To:	Hunter Ridley	From:	Paul Kos
	DRMS	Cc:	Jerald Schnabel, Castle Aggregate
Project/File:	Pikeview Quarry Reclamation Project	Date:	June 7, 2024

Reference: Responses to Adequacy Review for Technical Revision (TR-24), Pikeview Quarry, M-1977-211

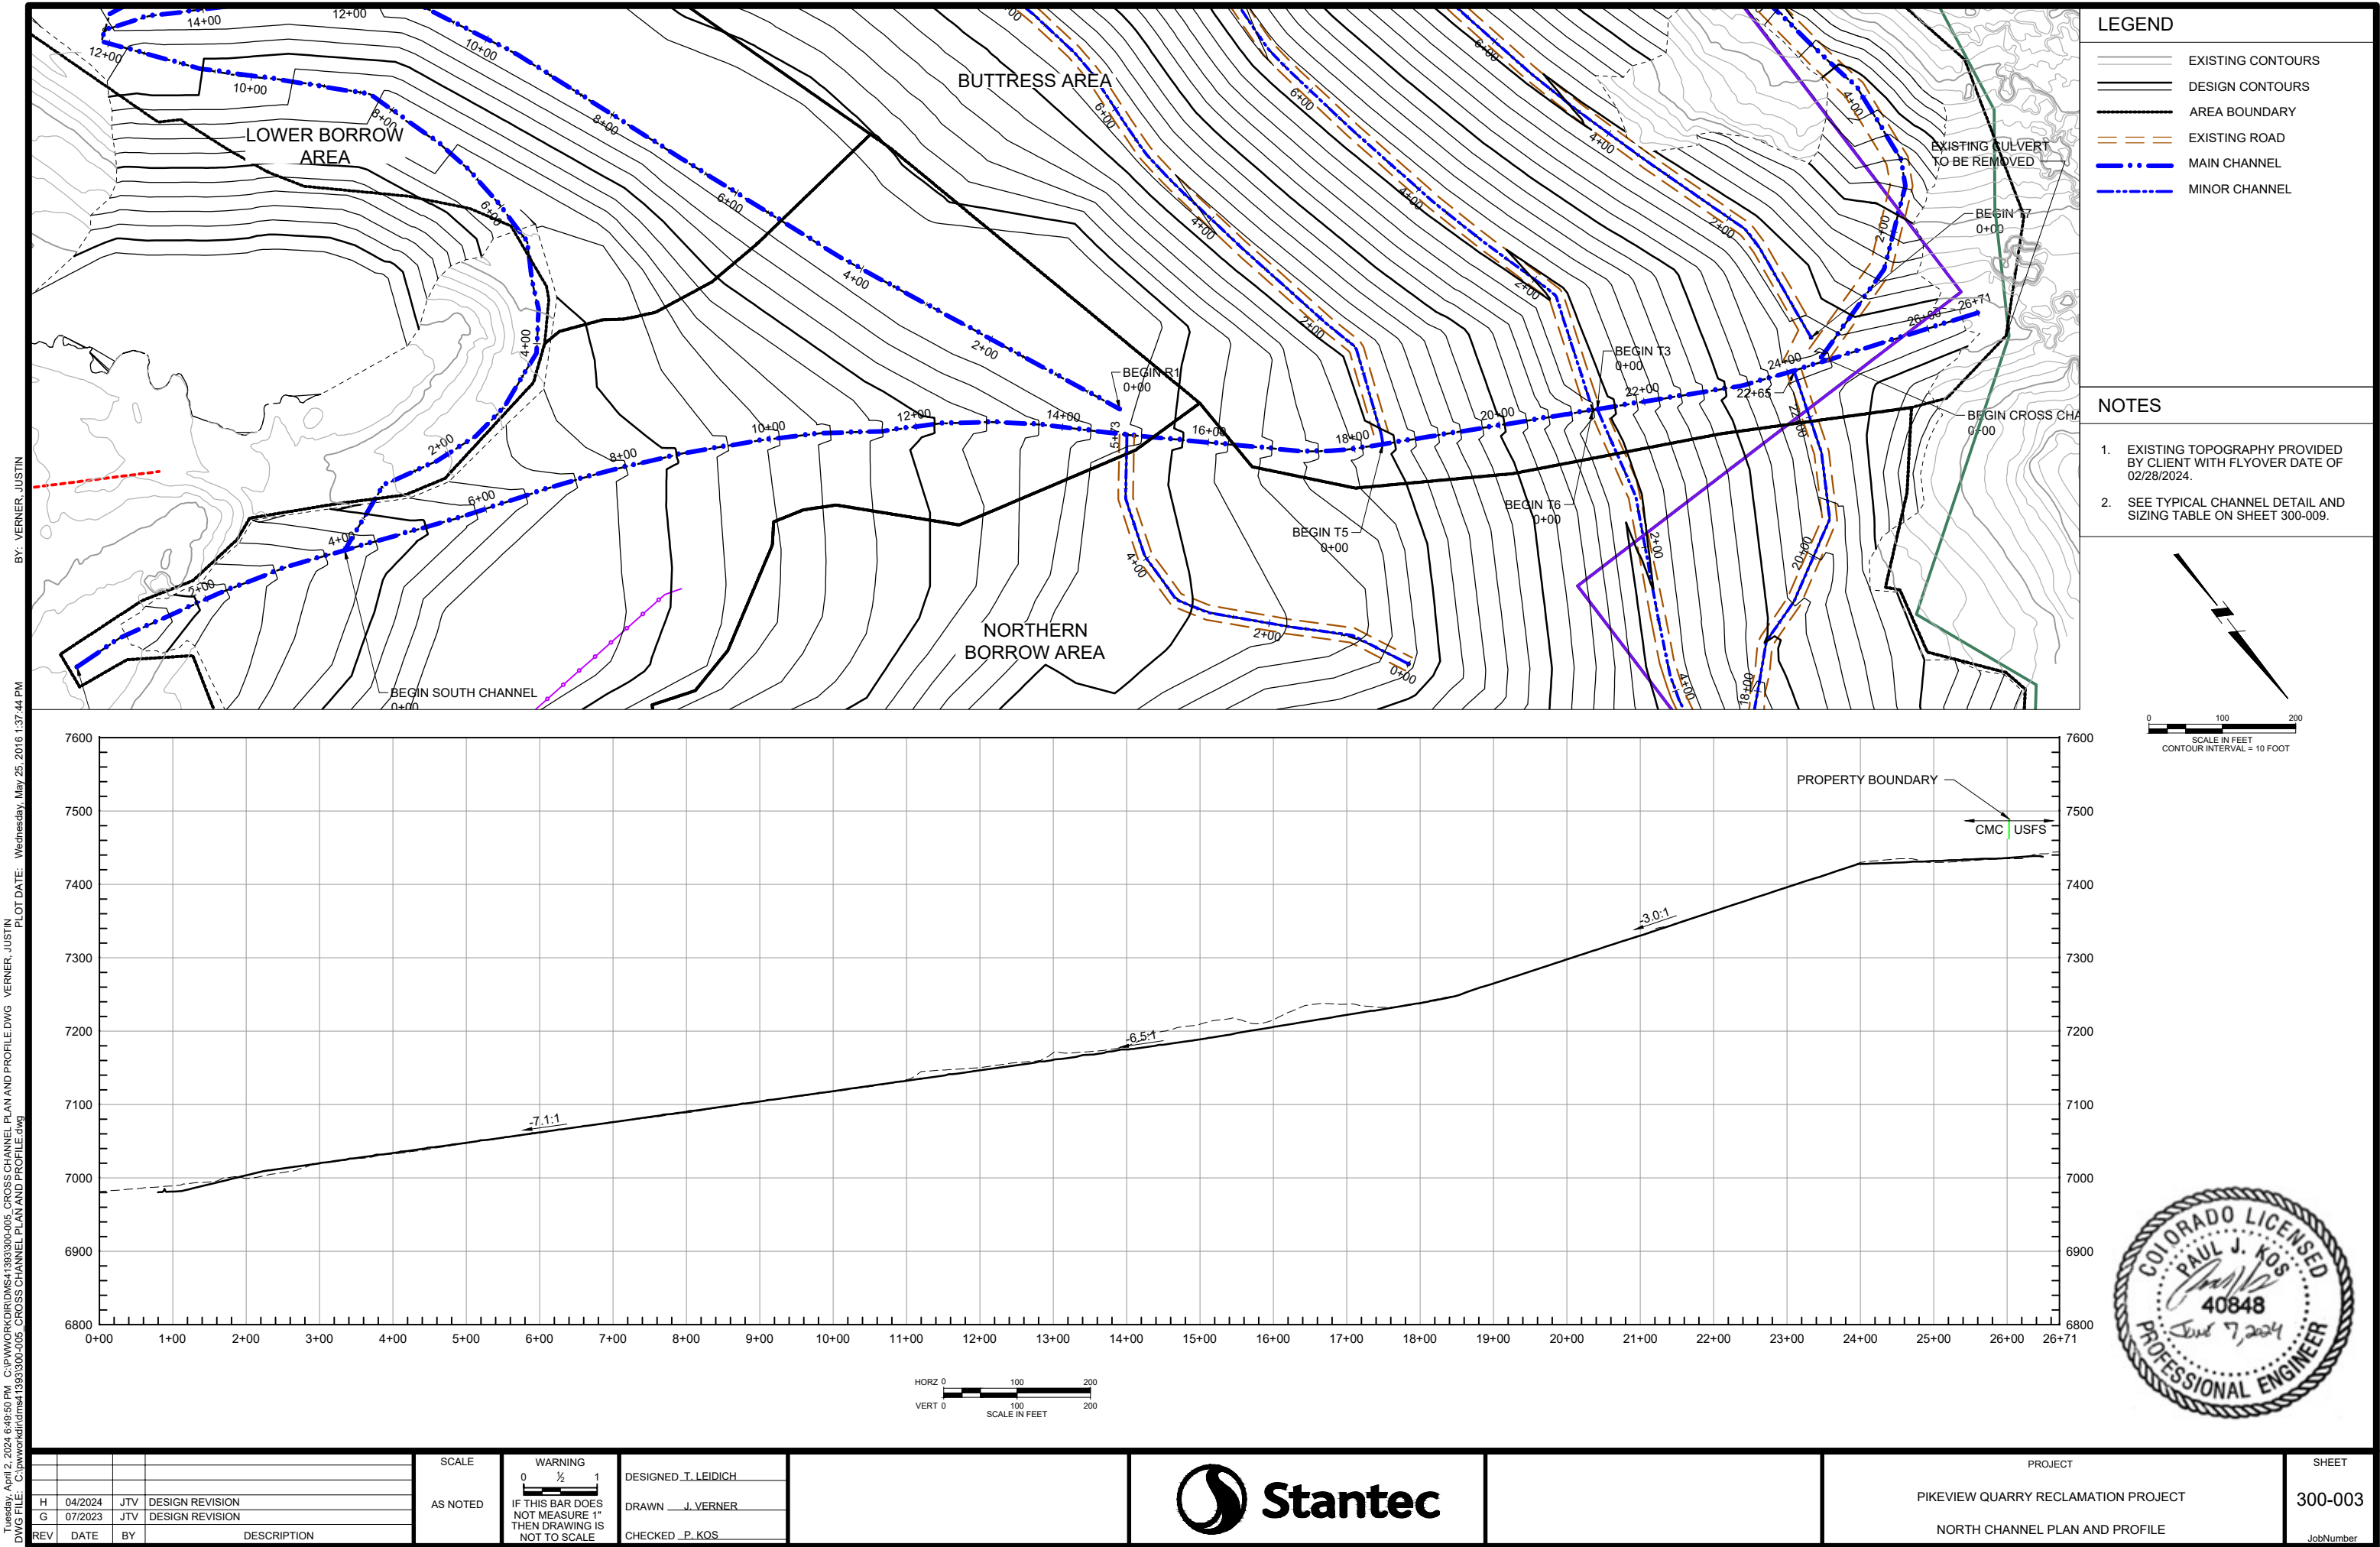
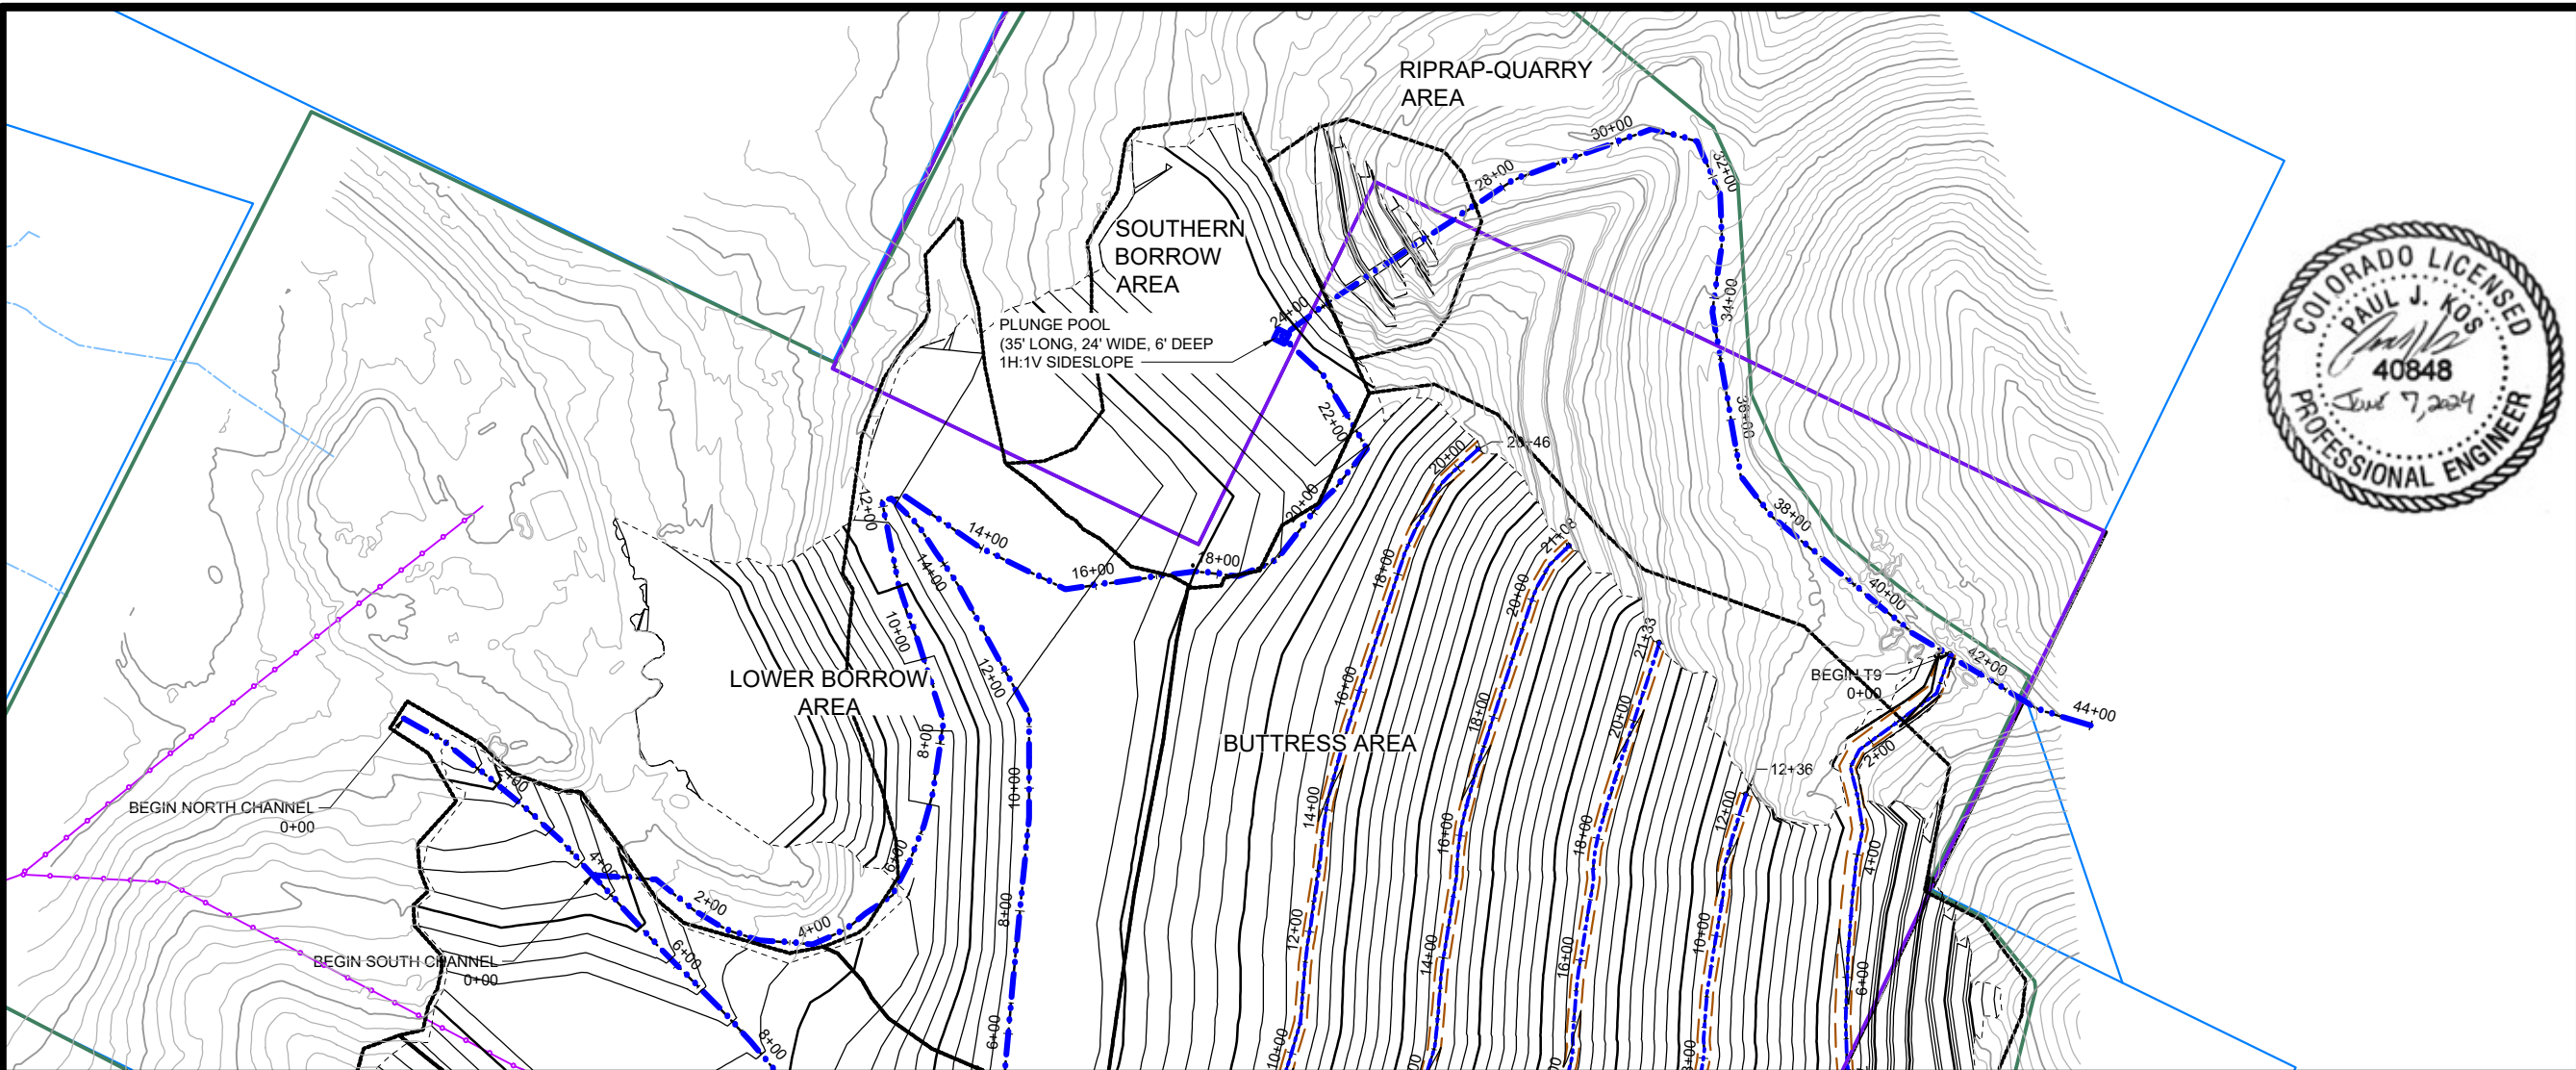
On Sheet 300-001 (Channel Plan), there is a label "Tie into Existing Drainage," but it appears that the leader associated with this label points to the wrong location. This drawing needs to be revised.

Response: The plan sheets have been updated to address Mr. Zuber's comments. The cover sheet was also updated with the revised sheet title. The updated sheets area attached.

SHEET
300-006
JobNumber

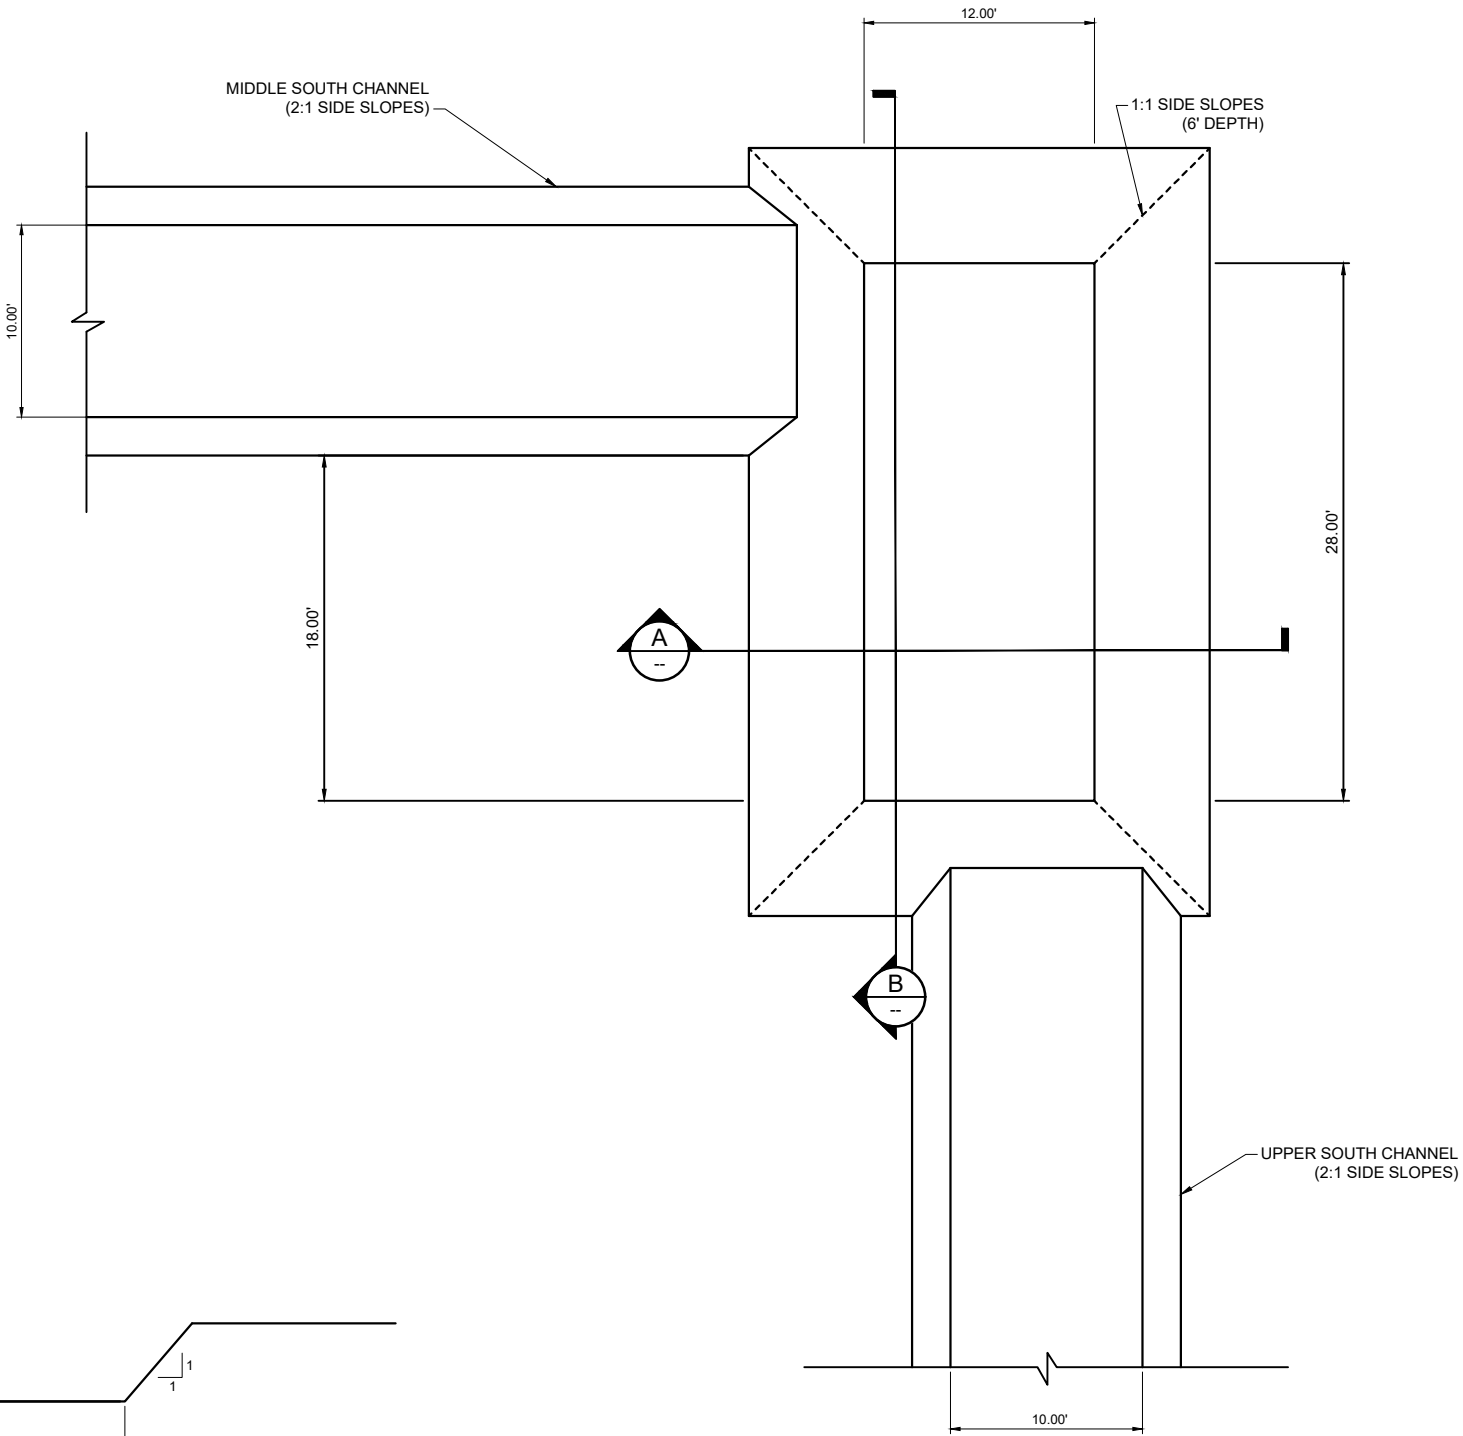
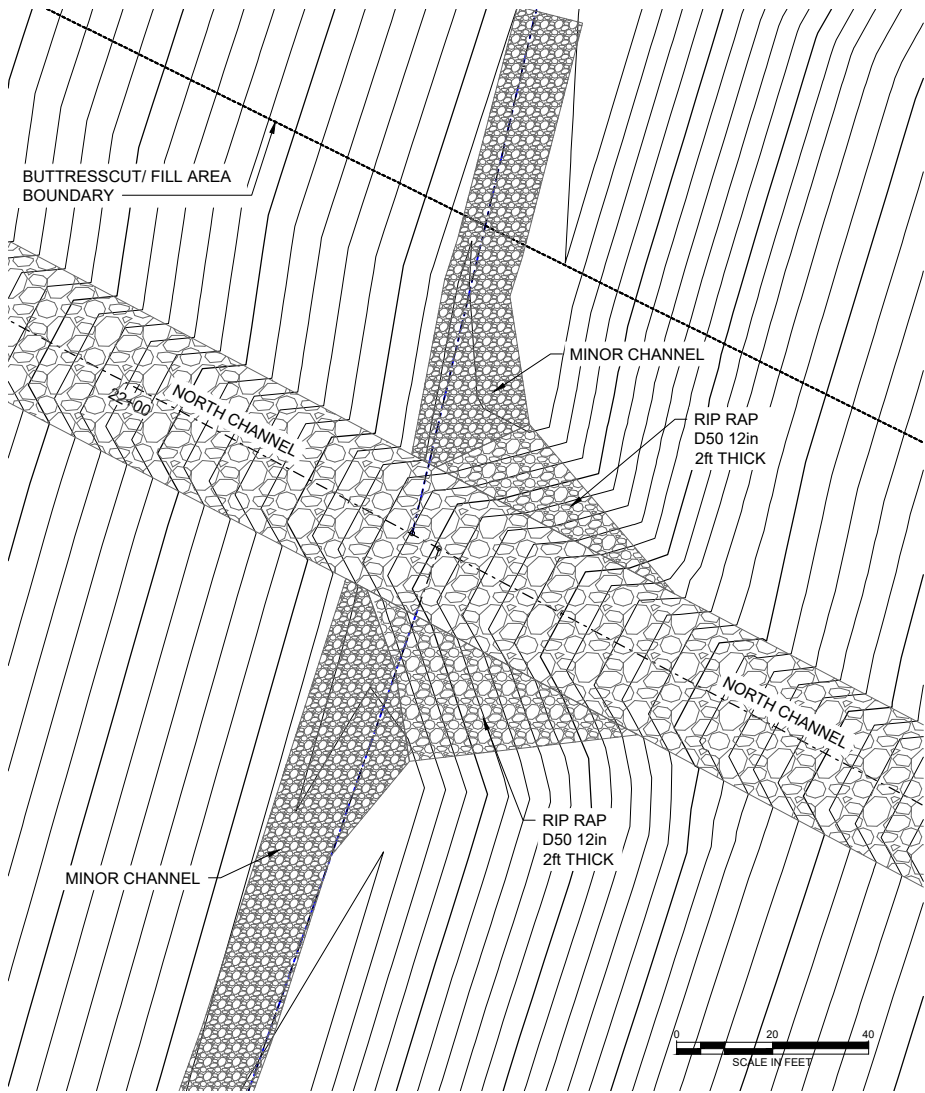
The title for Sheet 300-006 is "Transition Zone North Channel." However, this sheet also includes figures for the South Channel (namely, the Plunge Pool). The title should be revised to include both channels.
